NUMBER
COR61700

LINE	QUANTITY	UOP	CAT NO	ITEM NUMBER	UNIT PRICE	AMOUNT
				ADDENDUM NO. 1		
				SEE ATTACHED PAGES.		
				END OF ADDENDUM NO. 1		
0001	1	JB		988-68		
				PAVING: DRIVEWAYS, PARKING LOTS, TENNIS COURTS		
				***** THIS IS THE END OF RFQ COR61700 ***** TOTAL:

**SOLICITATION NUMBER: COR61700**  
**Addendum Number: 1**

The purpose of this addendum is to modify the solicitation identified as COR61700 ("Solicitation") to reflect the change(s) identified and described below.

EXHIBIT #2

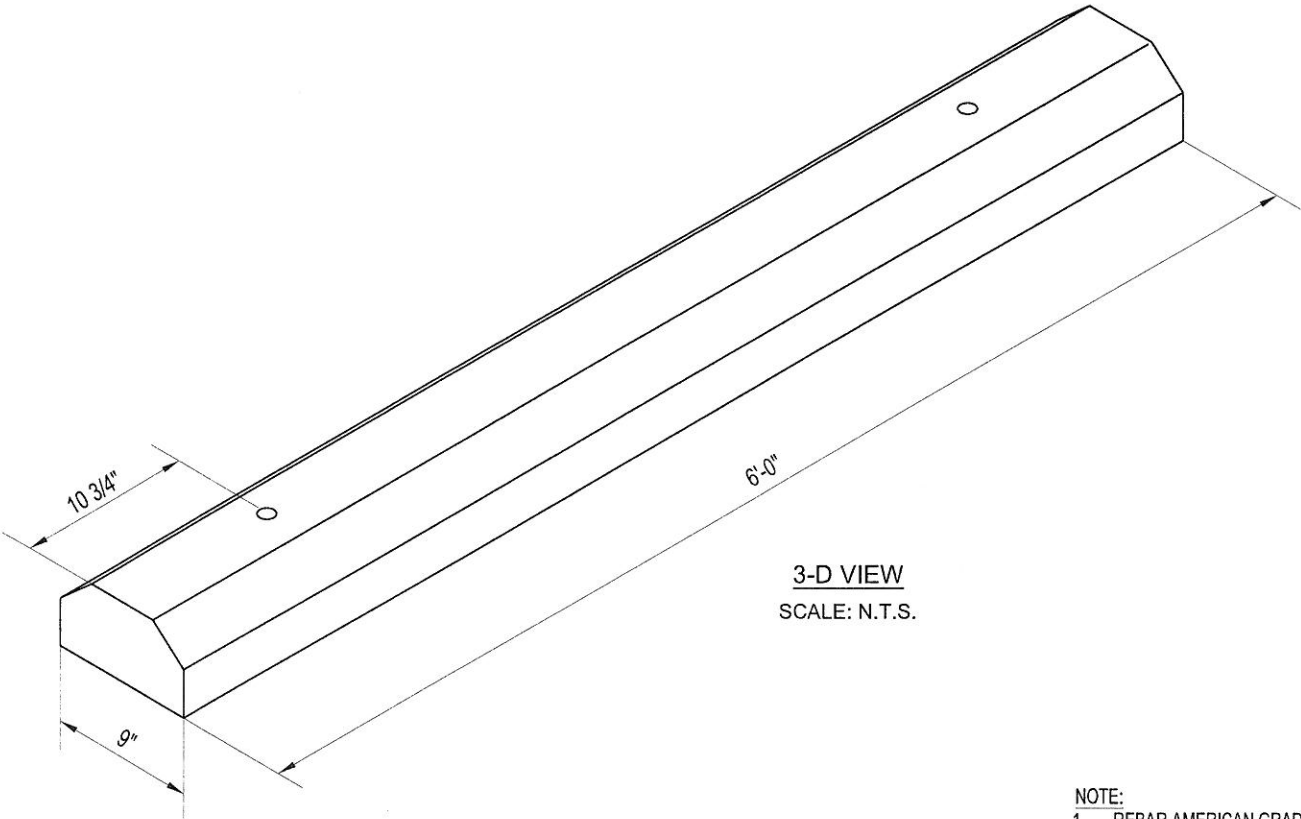
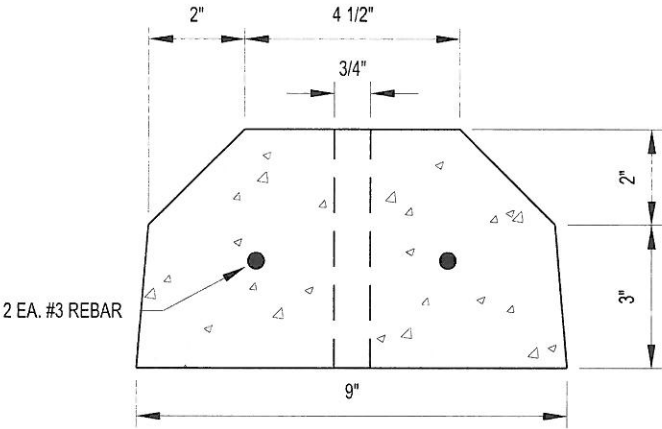
Q3: Is there a typical for concrete bumper blocks?

A3: See Exhibit #2.
